STATE OF NORTH CAROLINA
DEPARTMENT OF TRANSPORTATION

Subject: **Application for Individual Section 404 Permit, Section 401 Water Quality Certification, and Riparian Buffer Certification for U.S. 29 Interchange Improvements at SR 2790 (Eckerson Road)/SR 2526 (Summit Avenue) in Greensboro, Guilford County, Federal Aid Project No. NHS-2526(3), Division 7, TIP No. R-4707, Debit \$570 from WBS 36599.1.5.**

Subject: Project 36599.1.5 (R-4707) Guilford County
F.A. Project N/A
US 29 and SR 4771 (Reedy Fork Parkway) Interchange Improvements;
Improve Roadway, Modify Interchange and Replace Bridge 360

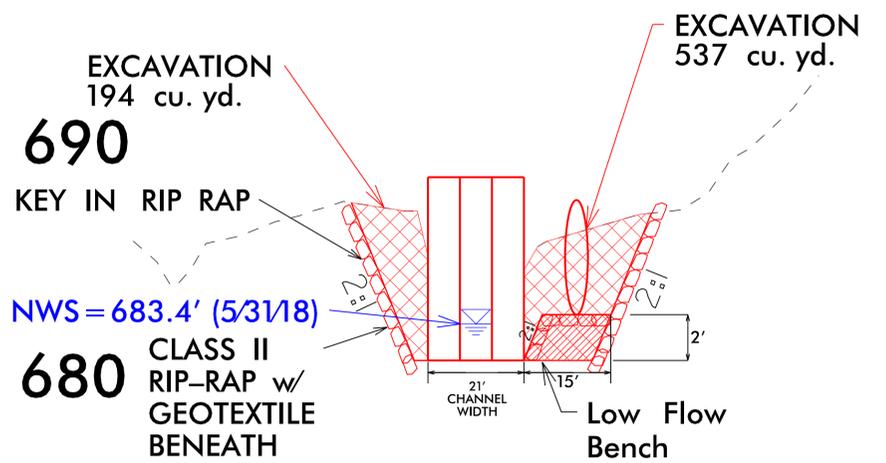
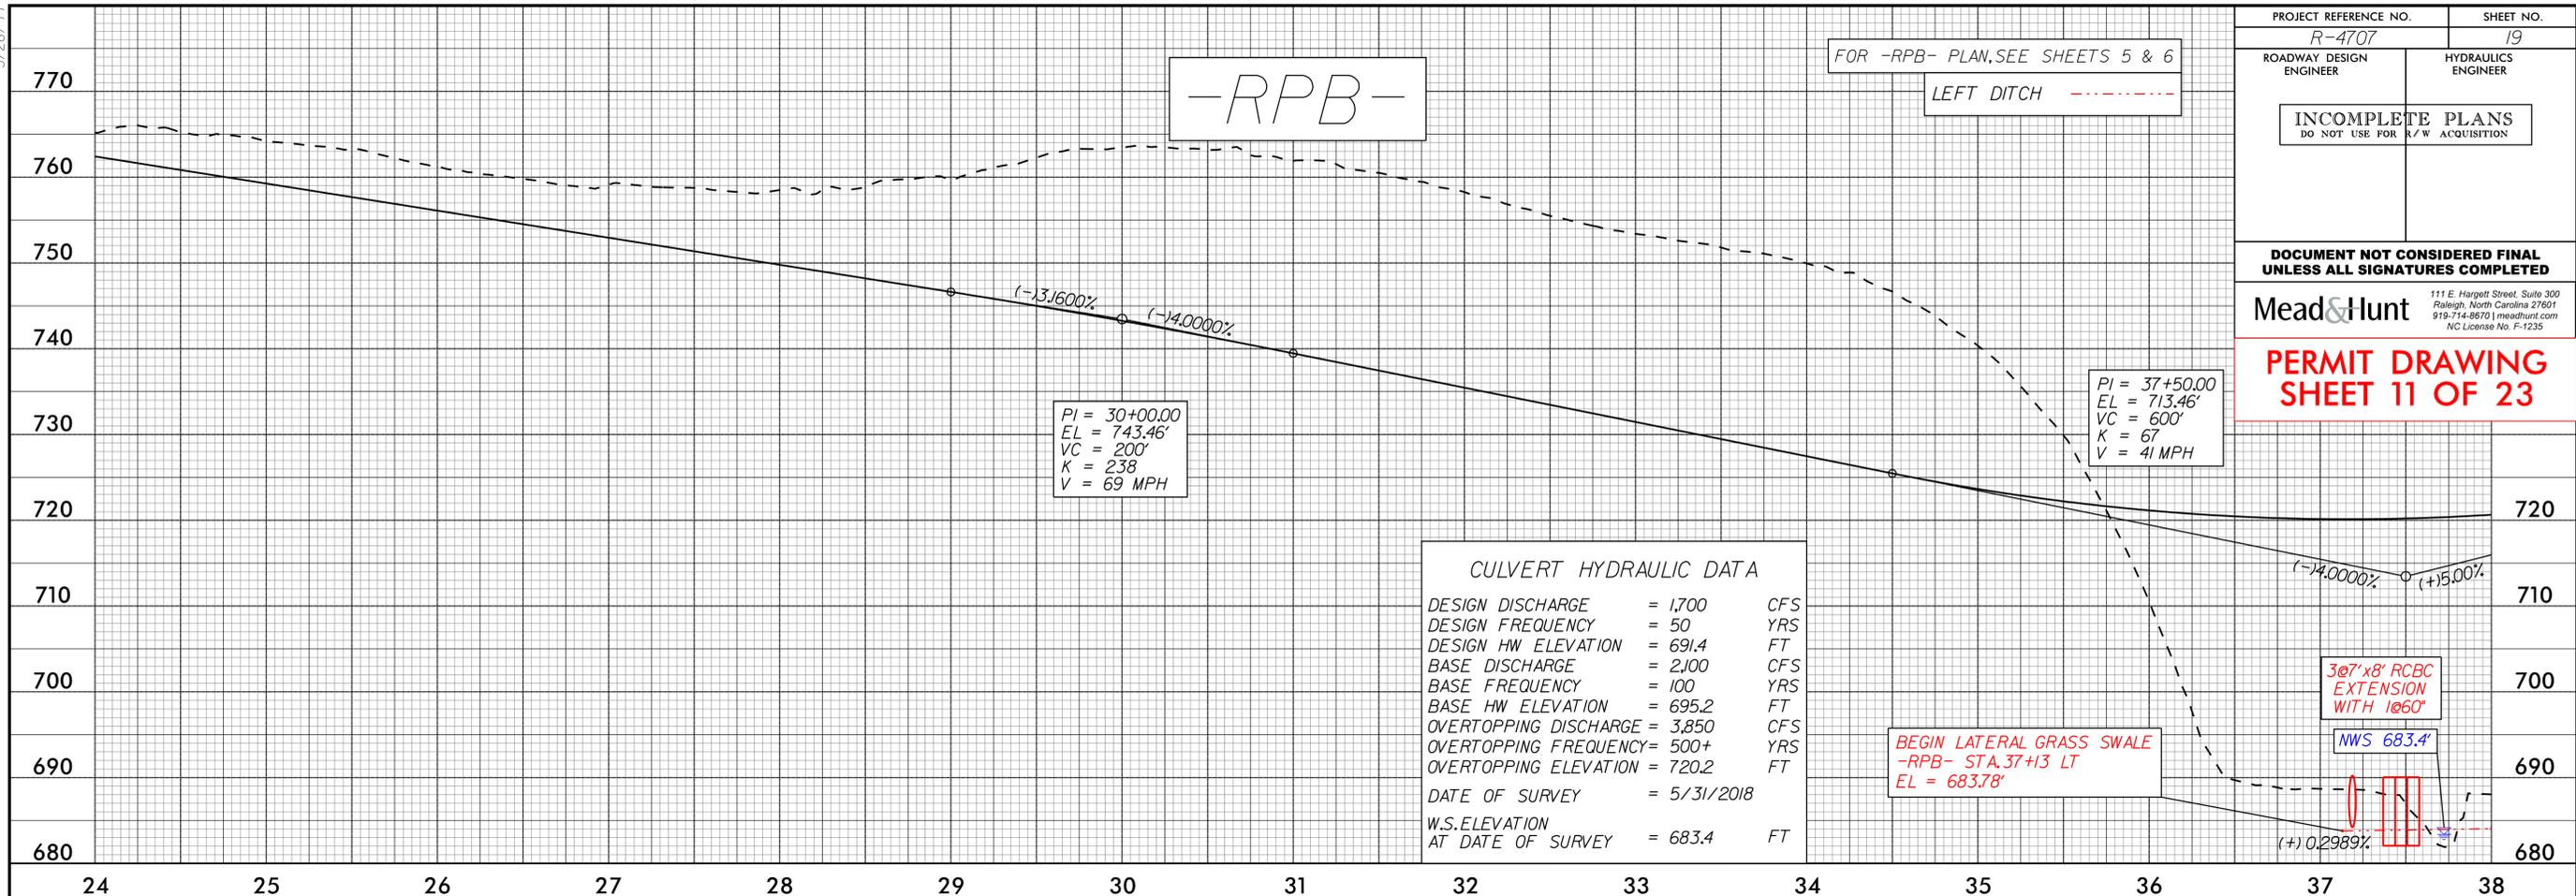
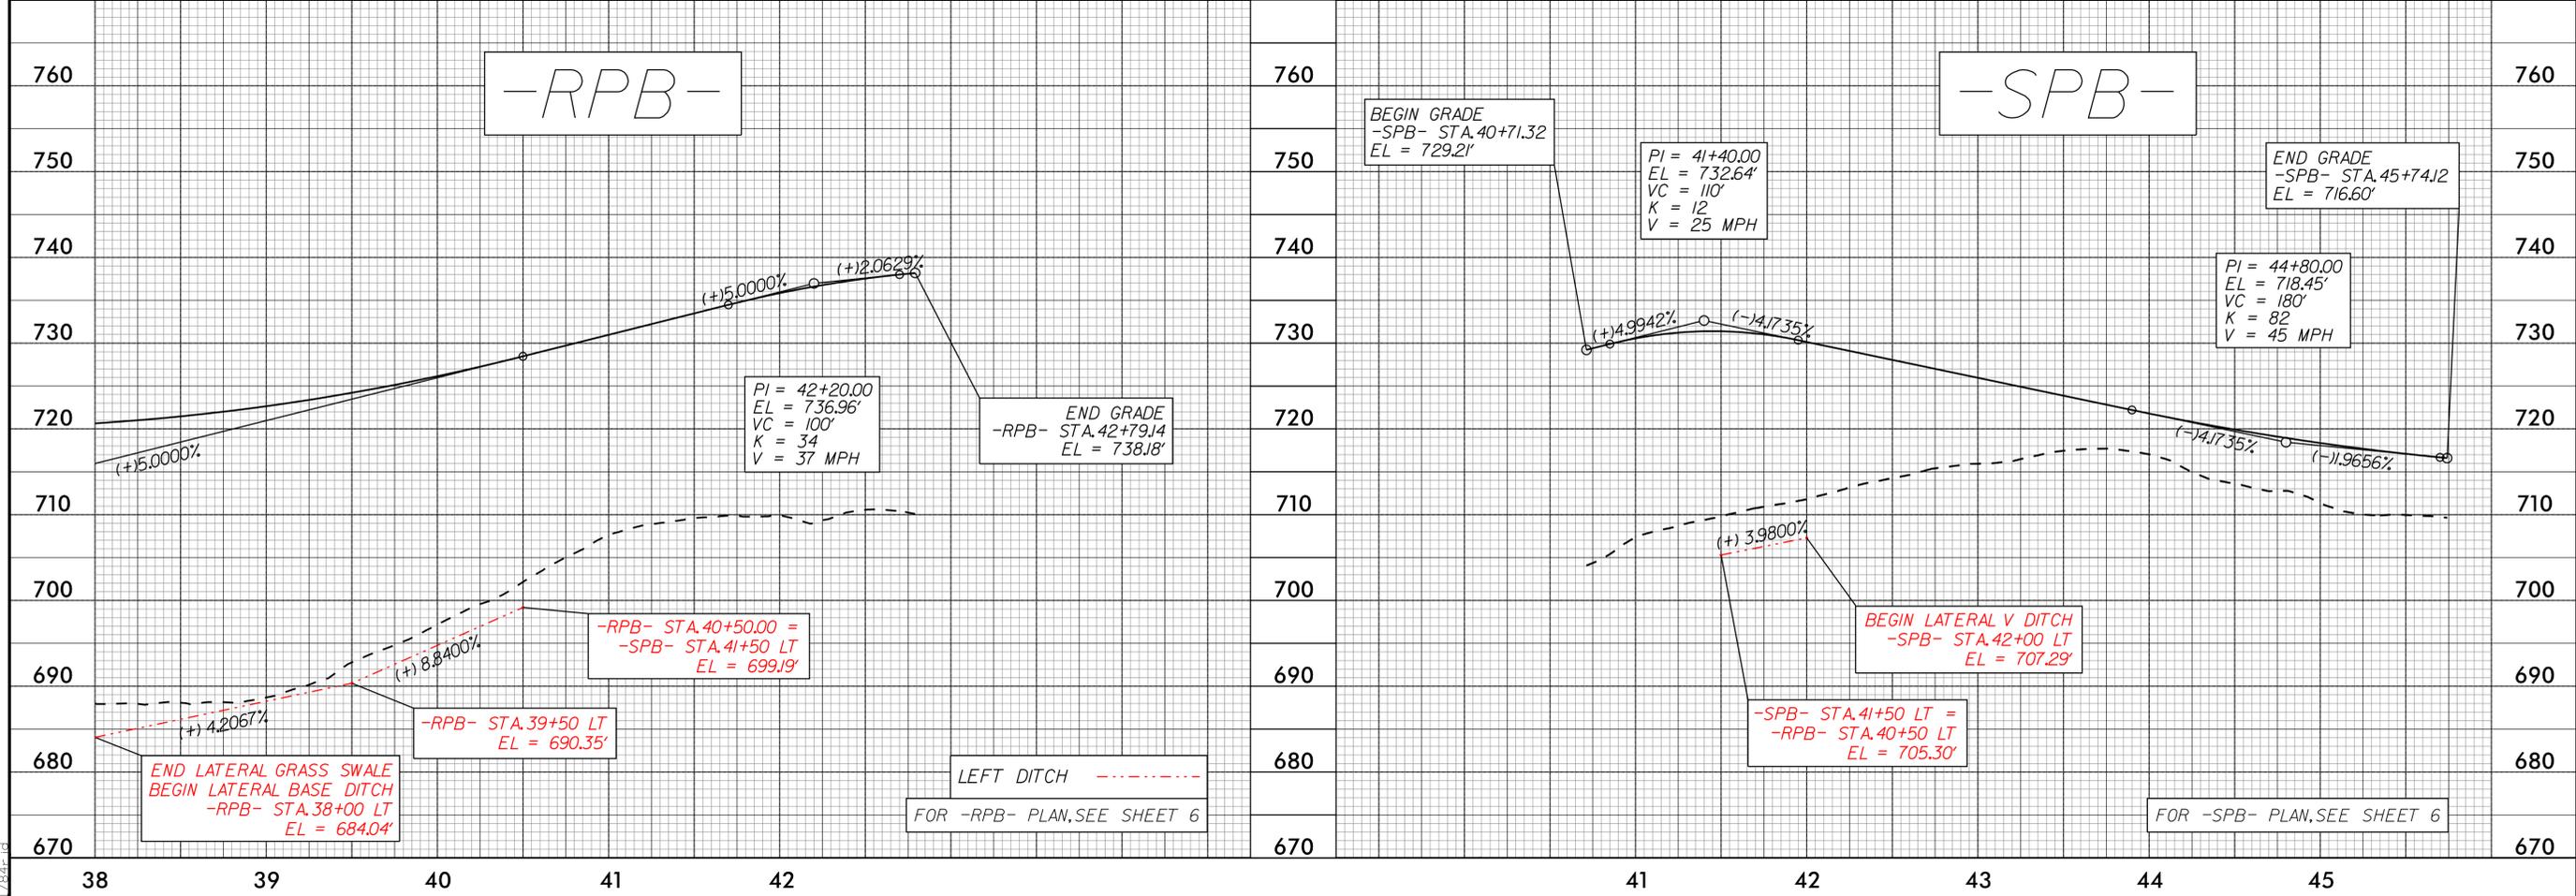
- Comment was made to revise hatching angle/spacing to ensure that hatching is visible for the entire length of the stream impact. The usage of a step-pool avoids an environmental impact to entire stream.

SITE 3C

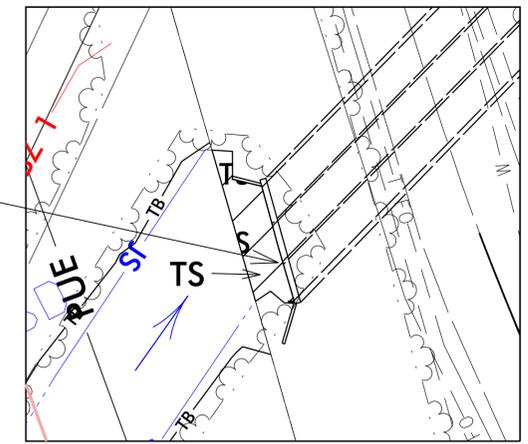
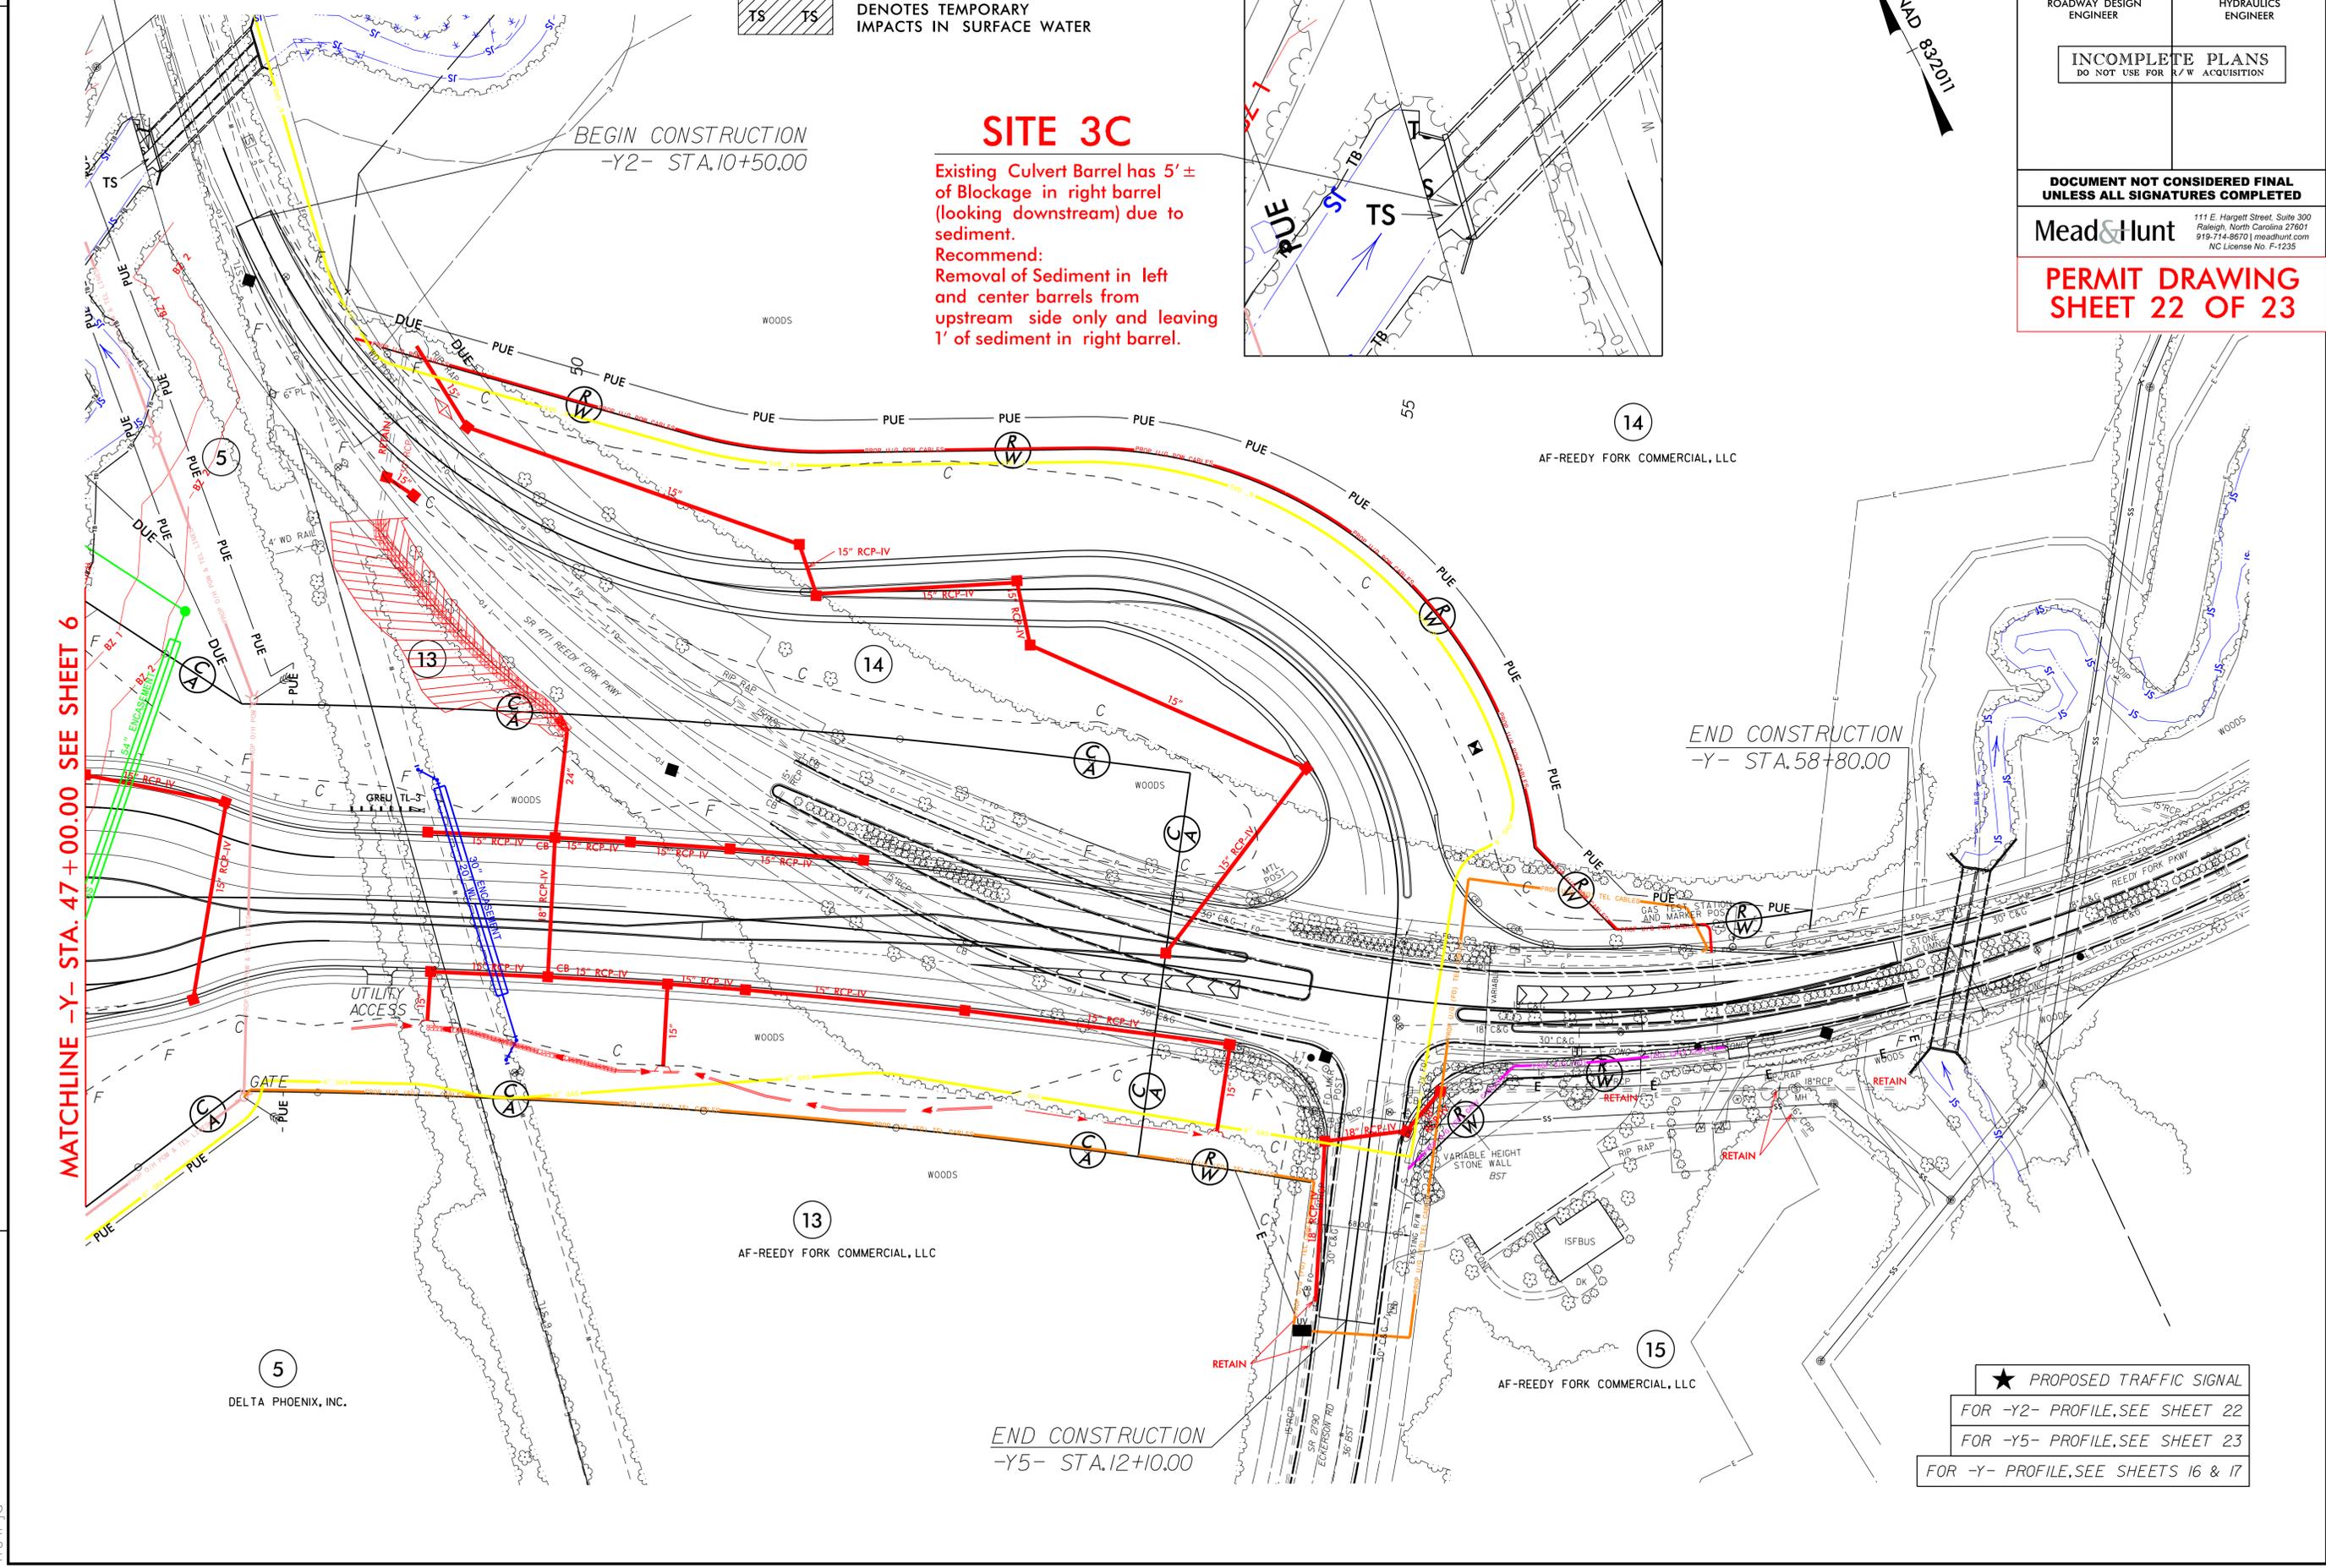
- It was noted that JS at approximately -Y- STA 30+00 Rt. begins downstream and off page before pipe outlet. Include the label "JS begins off sheet" for 4C permit drawings.
